### BD Micro Series Base Plate Earth Hole Position Modification

Fig. 1 Earth hole position

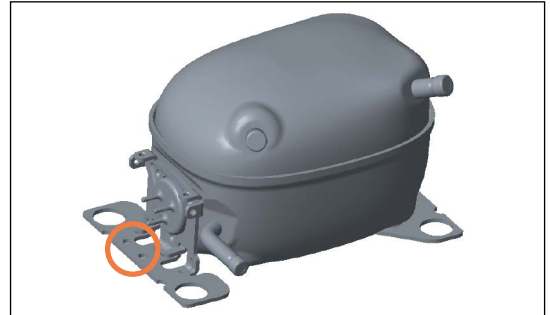
Until now, Nidec GA Compressors offered its BD Micro series with an earth hole in the center of the left side base plate on all BD1.4F-AUTO/ VSD/ FSD , and PBC compressors (see figure 1).

As the screwdriver accessibility to the center hole is pretty limited, we will add another 15 mm next to the original one (see figure 2) and on the opposite base plate (see figure 3).
